Geotechnical Risk- Restoration & Rebuild
of Reefton's Historic Power Project

Sarah Jean Smith

5/30/2013

Figure 1. Aerial photograph of the Reefton powerhouse project with site 1 and 2 annotated (altered after Archer 2012).

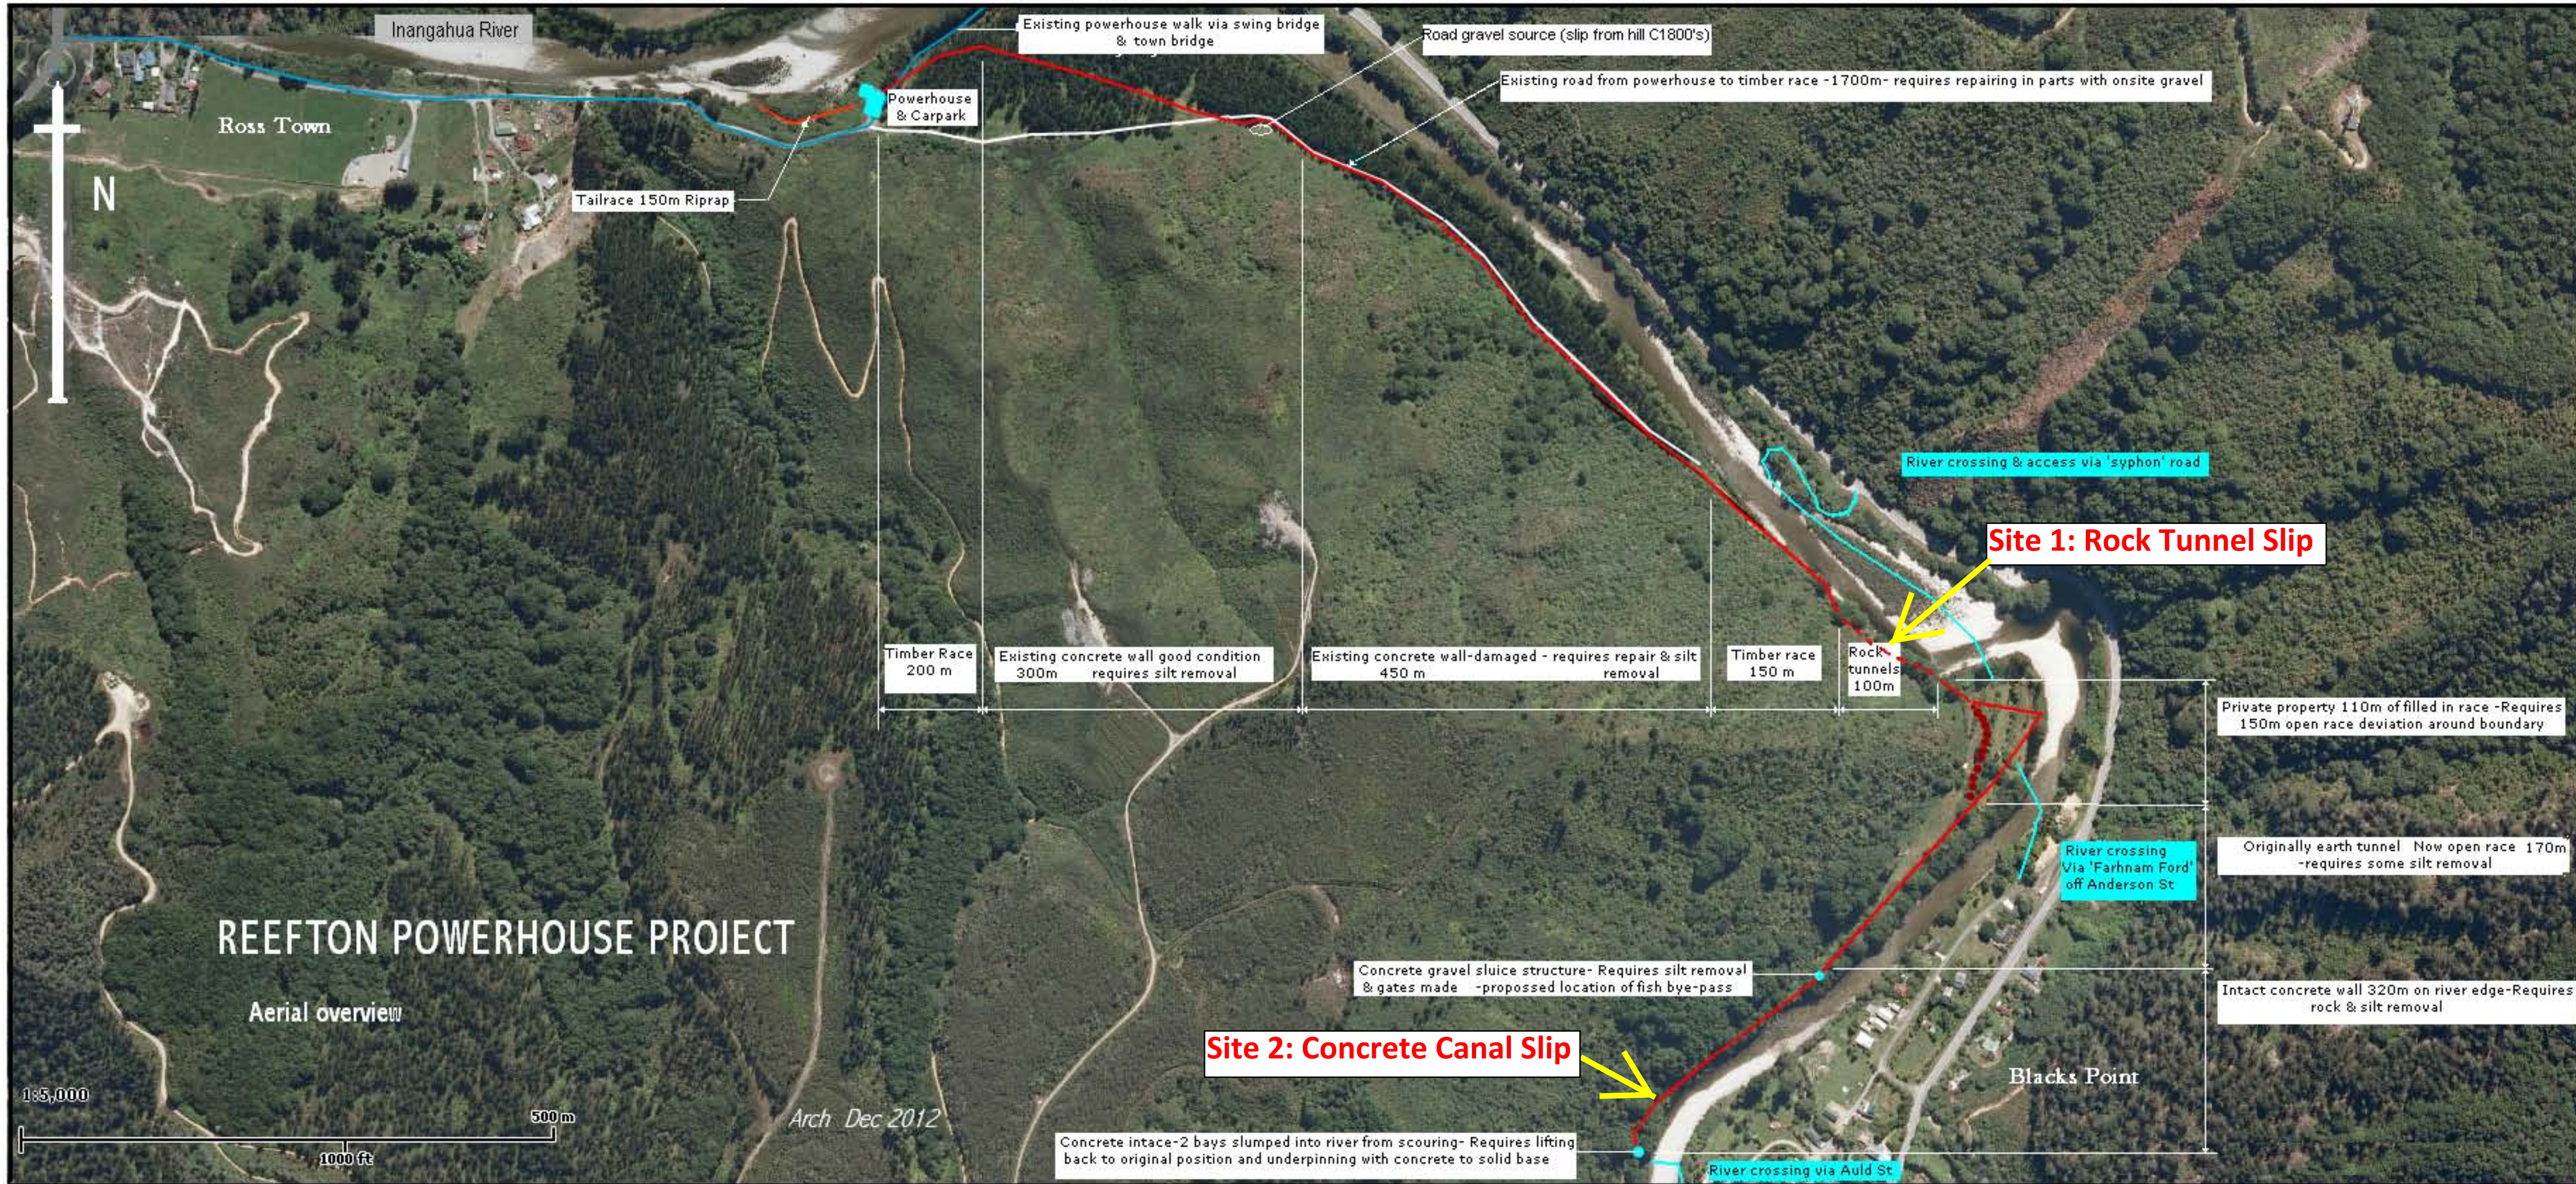
The concrete canal slip starts approximately 30 m downstream of the intake, and appears to be covering approximately 20 m in total length over the concrete canal (distances here are estimates only to discuss the general scale of the works). The proposed works discussed by Rebecca at this site is to excavate the slip from the canal before reinstatement can commence. A brief summary of what was seen on the site visit, along with several points for discussion are listed below.

- A colluvium slip (containing angular material from a close to source location), has come down from the bank above and deposited inside of the concrete canal. Vegetation is established on top of the slip and has stabilised the surface material for the time being.

- It is clear from bulging seen on the bank side of the concrete canal, at the downstream end of the slip that the canal has acted as a bunding to stabilise the toe of the slip at some stage. Bulging at the toe indicates pushing from behind, and may be a sign of that it was not simply an overtopping of material from above, but also of lateral spreading, which could indicate a larger unstable mass than what is evident at the surface. The nature of the concrete used looks to be low quality and unreinforced, this could have contributed to what is seen at the surface (essentially due to lack of structural strength).

- It is not known from the first pass review how far back into the bank until bedrock is intercepted, however there is competent bedrock outcropping in the stream.

- Based on the current proposal for the reinstatement of this section of canal, Geotech Ltd suggest that when works begin, a timeframe when low river flows are expected should be used, a ramp is constructed using river material on the outer (river) side of the canal to gain access to the site should be constructed (after excavation natural scour should remove this material). Excavation should be carried out by a 20 T hydraulic excavator. Assessing of the concrete walls should be carried out during excavation of the in filled section of the canal, under careful supervision of an engineer with suitable experience, along with some basic survey to monitor any movement that may occur on the slope. It is suggested that a structurally reinforced section of concrete replaces the bank side concrete wall to minimize any future bulging which may occur as a result of future bank failures in this section. Rip-rap should be placed on the bank above the concrete canal in an effort to put weight on the toe of the slip. With this option Geotech Ltd stresses that excavation of the historic canal at site 1, may induce unforeseen geotechnical failure which will be difficult to budget for, and cannot back that the removal of this material will not adversely affect the current landscape above.

- Geotech Ltd suggest that the a new straightened alignment around this slip is installed, which will have minimal impact on the existing canal structure; with the exception of a diversion upstream and downstream of the slip, and therefore the historic integrity of the scheme will remain intact, and there will be minimal risk of inducing failure of the slip above. Design of the proposed new alignment seen in Figure 2 should include the placing of rip rap above the new bank side of the canal to reduce the possibility of further natural failure of the slip. Costing for such a project will be simplified, as there will be less financial risk associated with the unknown ground conditions which may be encountered with the above proposal. Concerns have been raised with regards to the impact on the river that this might

cause for neighboring properties, but two points should be brought up here, since the scheme was abandoned the riverbed has lowered more than a meter according to Watson (2013), and that water will be essentially still travelling in the current location, but will be segregated (i.e. within the canal and in the natural river course). *It is recommended that this is peer reviewed by a hydrologist to provide support on rationality.*

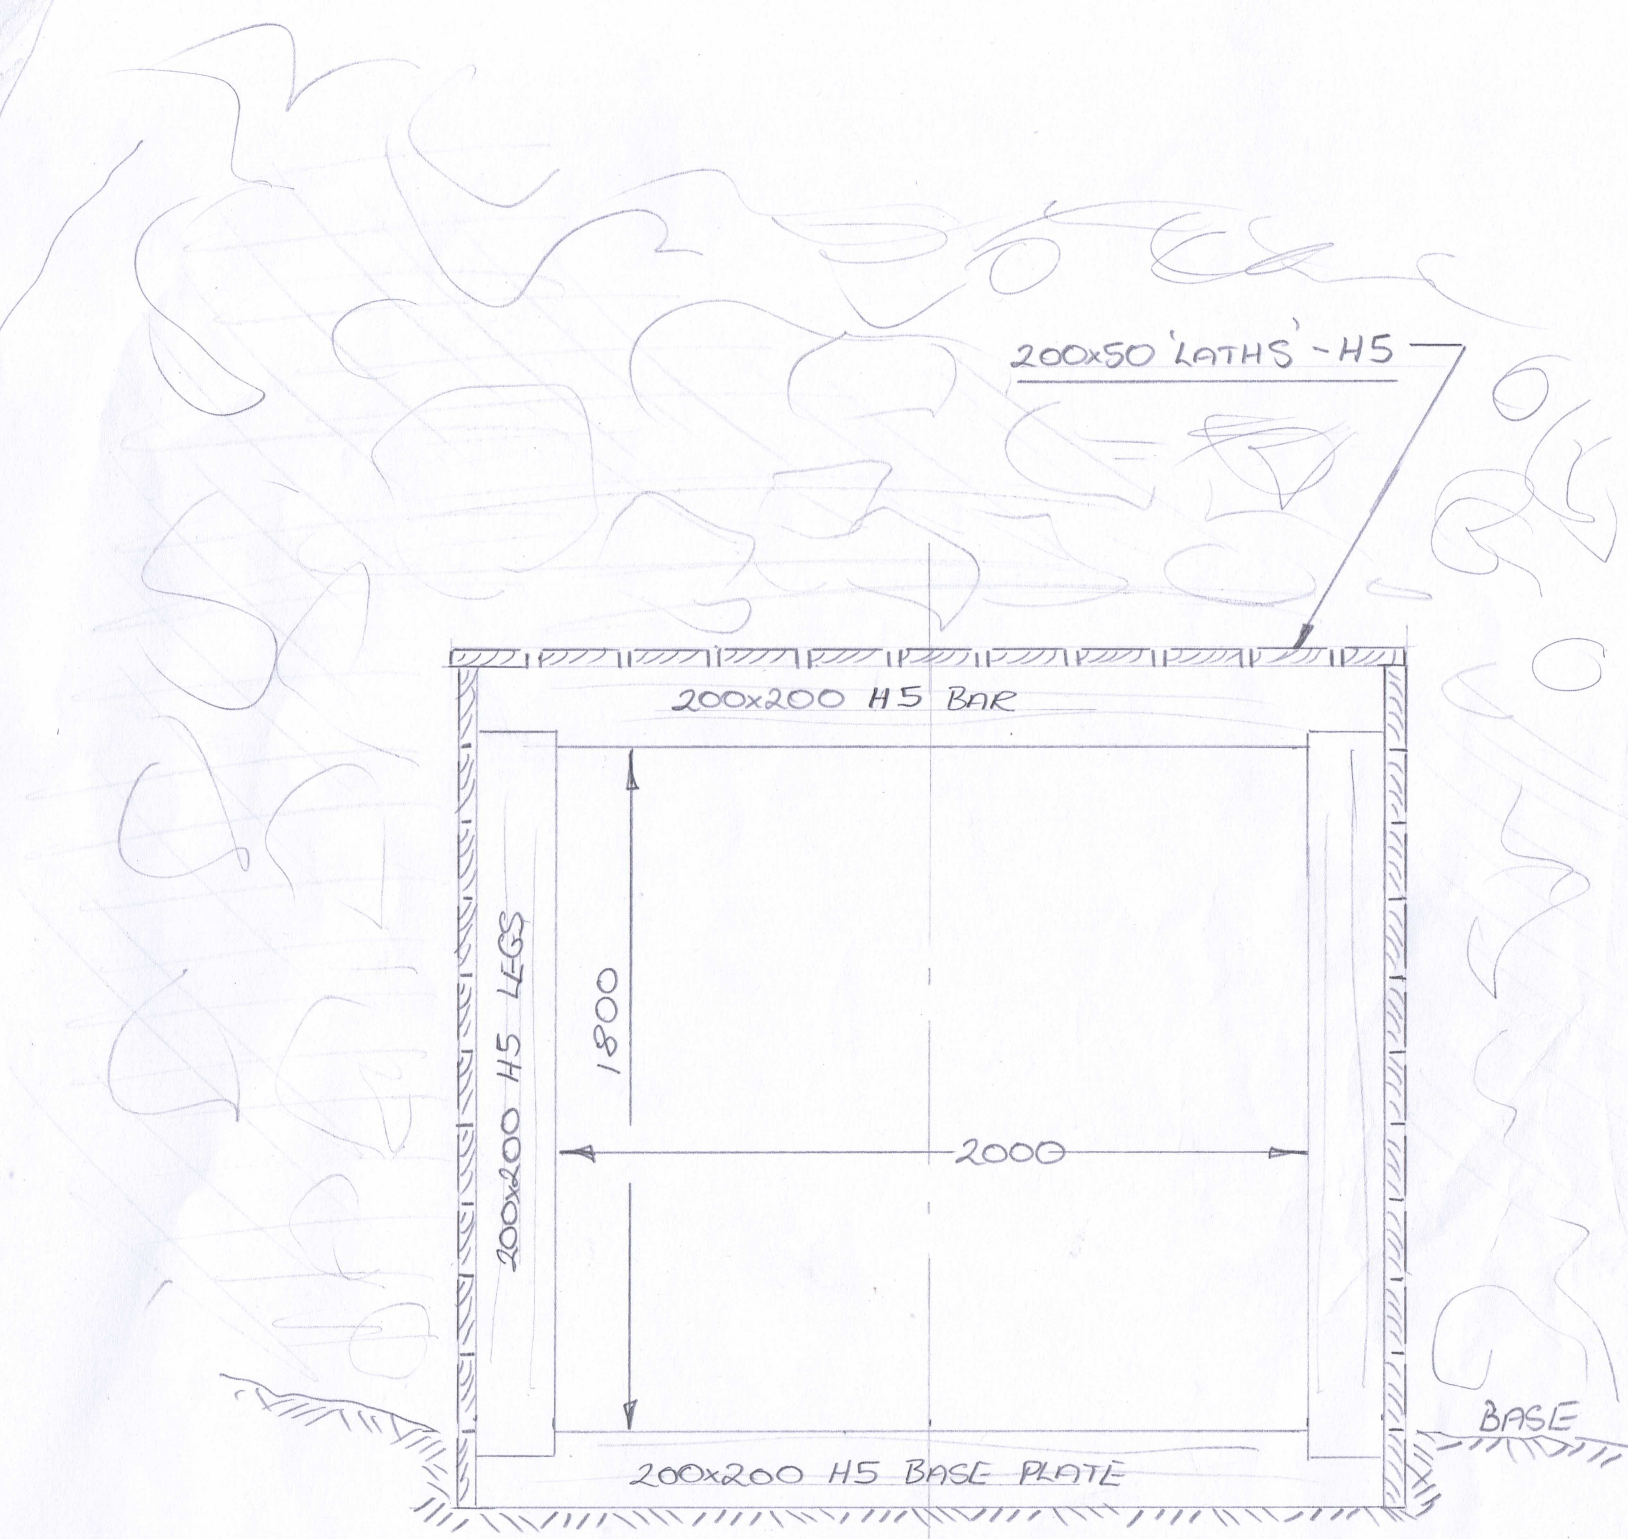
- Large rip-rap should be placed at the toe of the slip to effectively buttress the slip in the final design, the rip-rap should be placed up to at least the level indicated in Figure 4, large rip-rap placed at the toe of the slip will reduce natural scour from flooding. Slip material should be landscaped above this level; the angle of the final landform should be approximately 38 degrees/ the angle of repose (or lower) for longevity of the slope.

- It is recommended that the large tree located just above the upstream portal seen in Figure 4, is removed due to the effects the roots will have on the tunnel entrance.

Figure 3. Rock tunnel slip remediation design (Archer 2013).

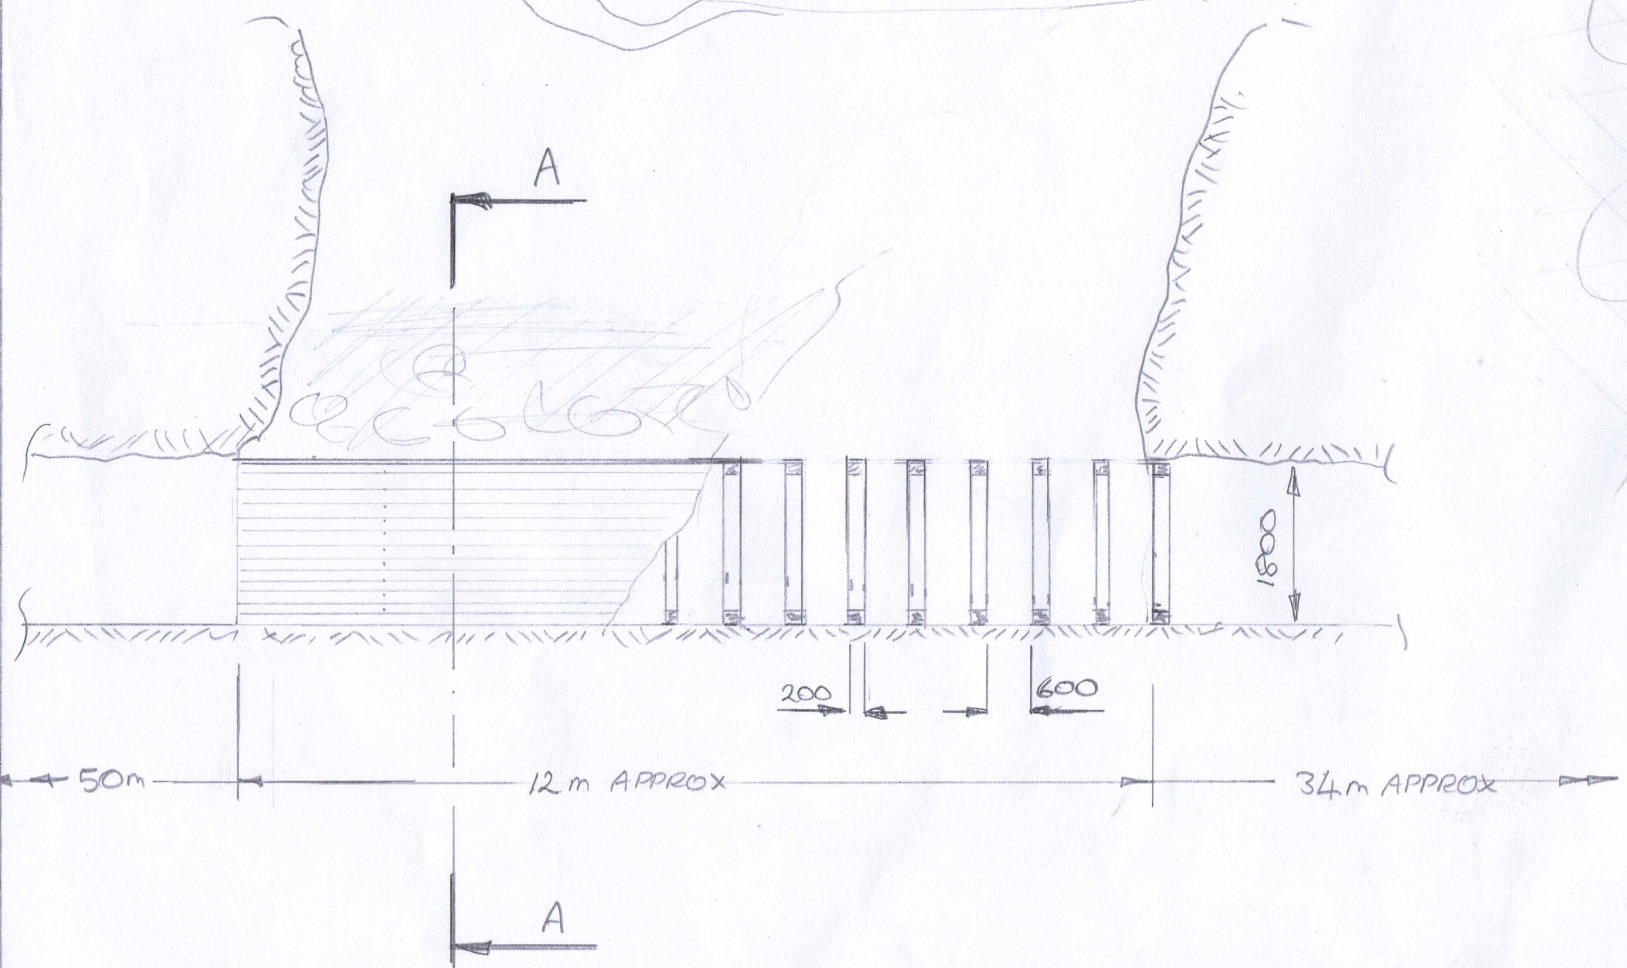
The rock tunnel slip is located approximately a third of the way down the scheme's waterway, and can be seen in Figure 1. The affected section of approximately 12m chainage has left 2 portals daylighting at both sides, and a localised slip through the centre. Figure 3 shows an outline of the proposed remediation of this section from Allan Archer. A brief summary of what was seen on the site visit, along with several points for discussion are listed below.

- It is recommended that the structure that bridges the two portals is designed for a dead load of at least 16 T per lineal meter to allow for the weight of 3 to 4 vertical meters of material to sit on top of the structure.

- It is recommended for a quick installation that the bridging is pre-cast or already built prior to installation, so that it can be lifted and lowered directly into the excavation, minimizing the need for workers to be placed in any hazardous positions, attached is the NZ regulations for working in excavations.
